Subject: Chula Vista Energy Upgrade Project (07-AFC-4)  
Data Adequacy Supplement

**In Response to Data Adequacy Review**

**Chula Vista Energy Upgrade Project**

**FIGURE DA3.0-1a**  
**EXISTING ONE-LINE DIAGRAM FOR**  
**OTAY SUBSTATION**  
CHULA VISTA ENERGY UPGRADE PROJECT  
CITY OF CHULA VISTA, CALIFORNIA

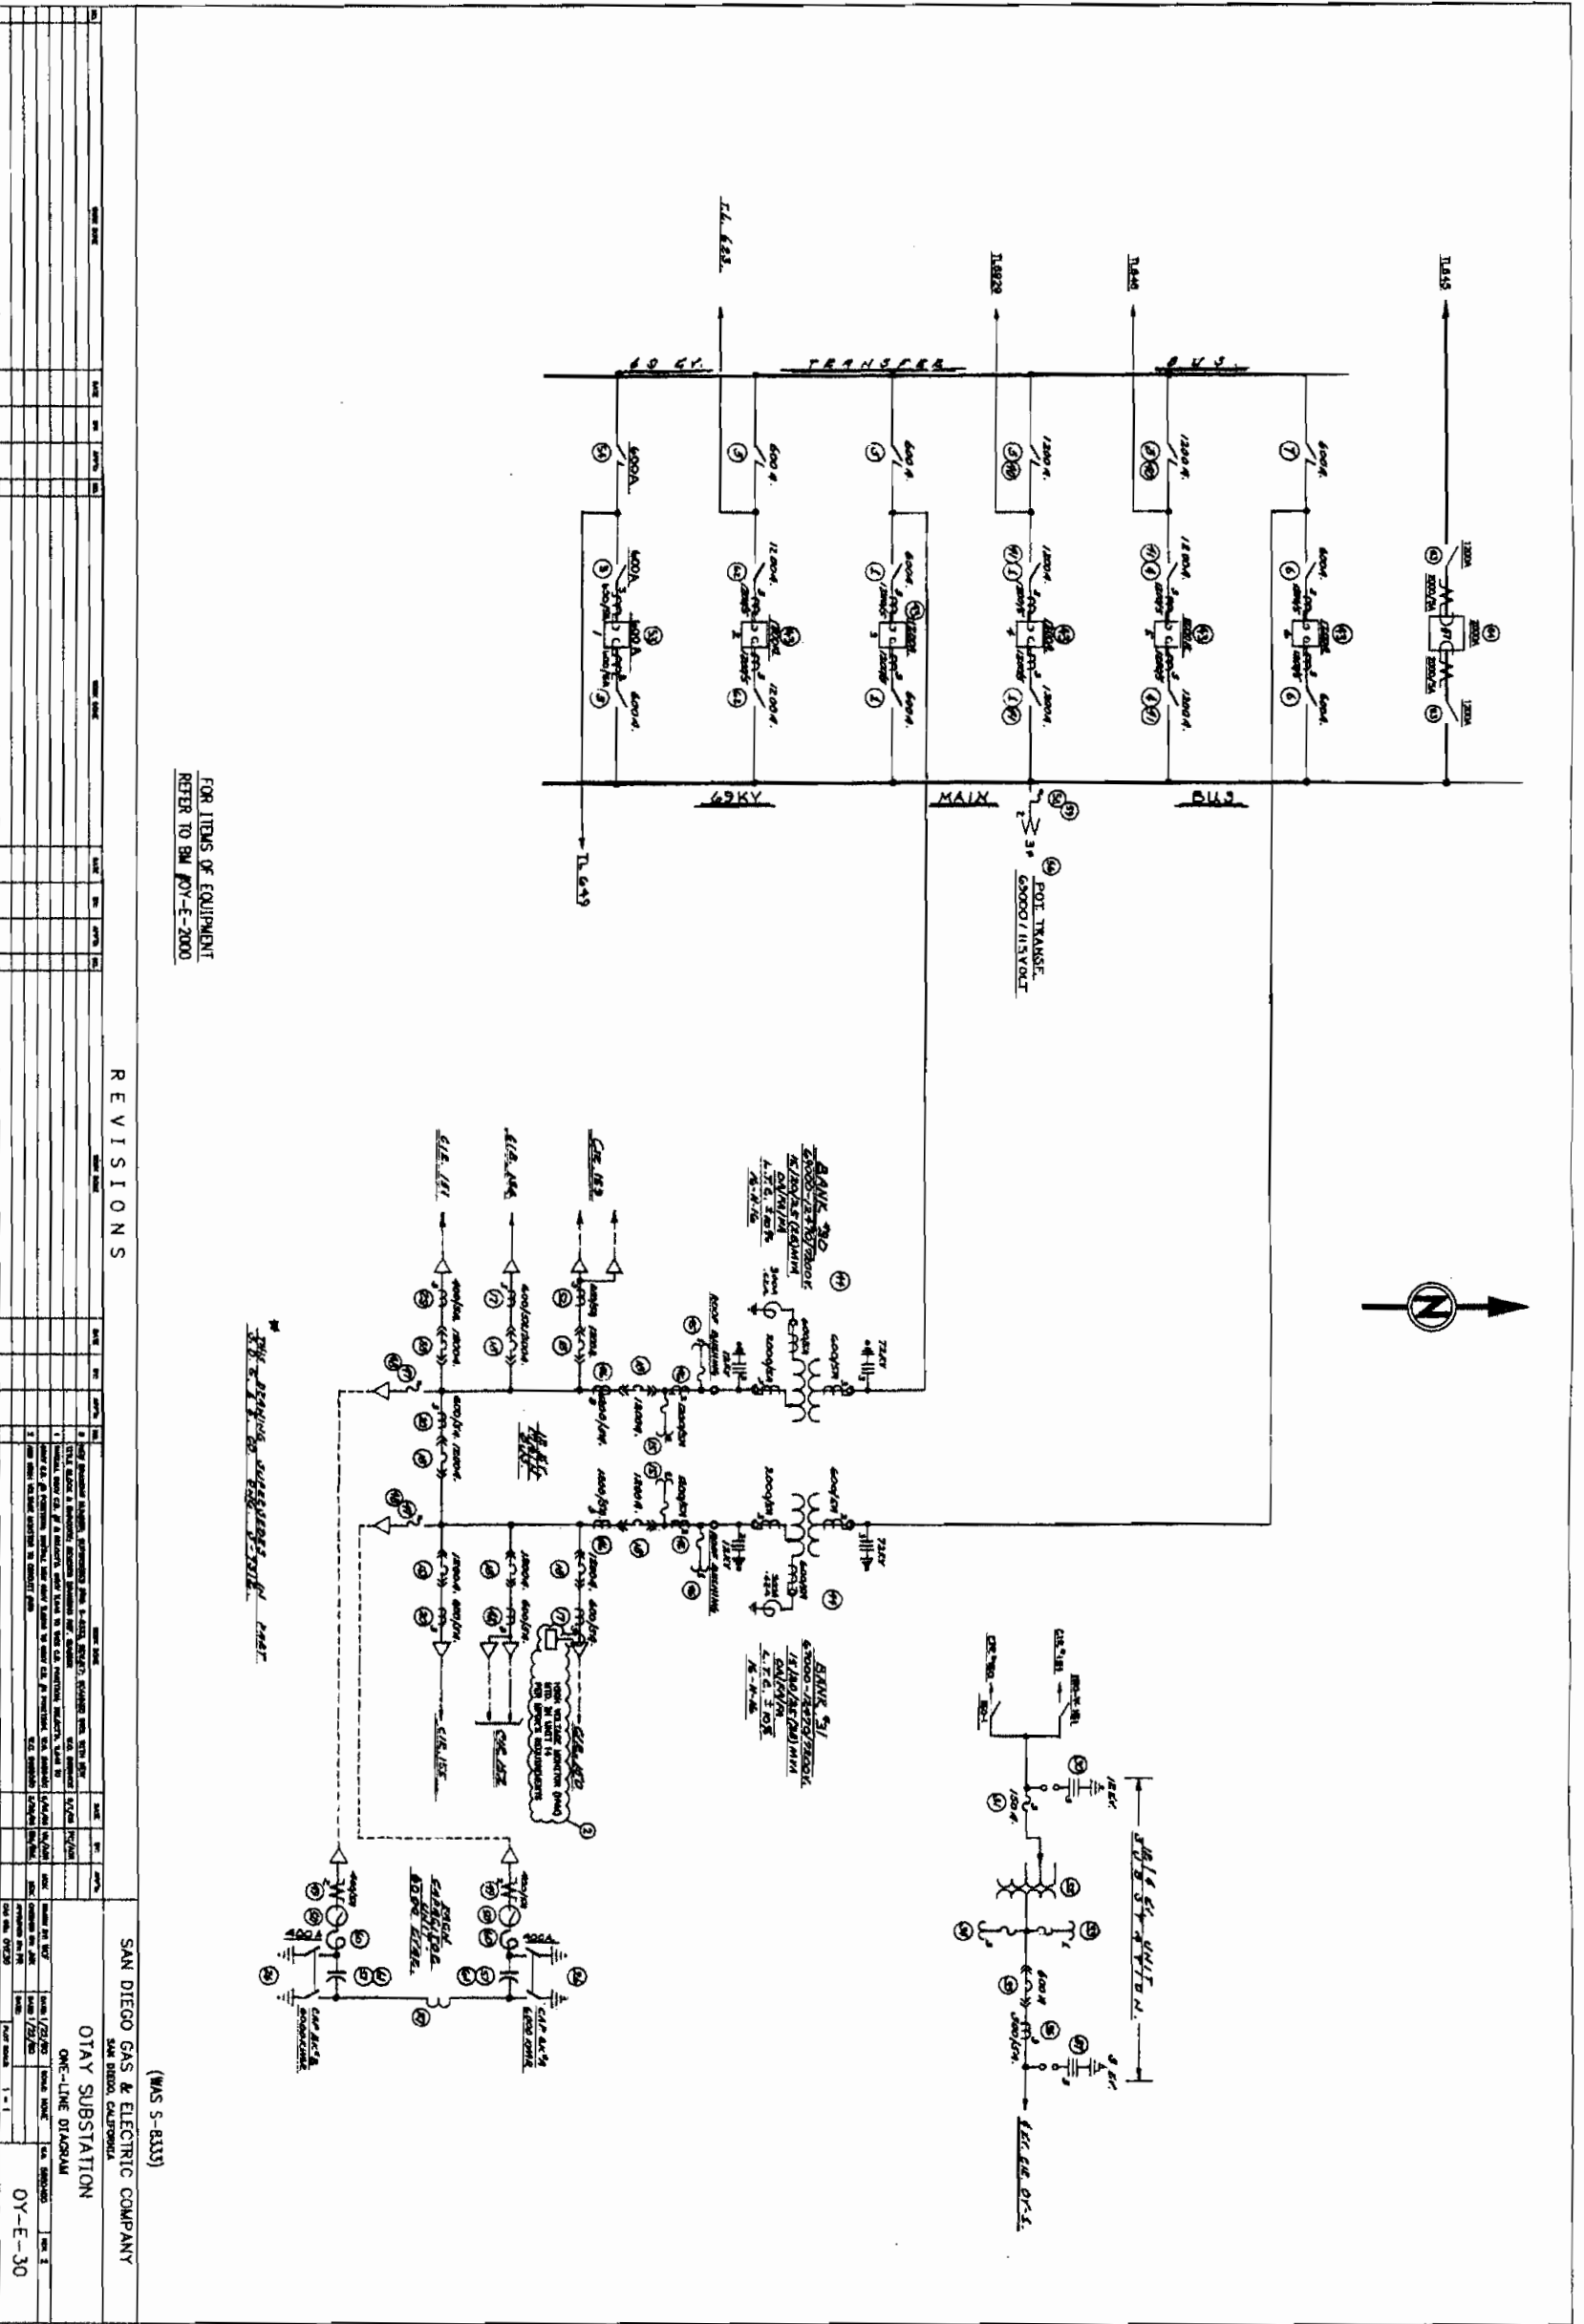
1. Provide a one-line diagram for the Otay Substation before the interconnection of the project.
2. Provide a one-line diagram for the Otay Substation after the addition of the project. Show all equipment ratings including breakers, disconnect switches, buses, and etc. which are required for the addition of the project.
3. Provide detail information on the required transmission line upgrade listed on section 3.3.3. Show exact location of the reconductoring section, conductor type, conductor rating, and the required pole structures, size and number of poles required.

**Response** – Figure DA3.0-1a includes a one-line diagram of the Otay Substation as it is currently and Figure DA3.0-1b is a markup of the one-line diagram showing changes to breaker ratings that will be required to handle the higher voltages that the CVEUP will supply. The connection between the CVEUP and the Otay Substation is made through Tie-Line 6929, as indicated on Figure DA3.0-1b.
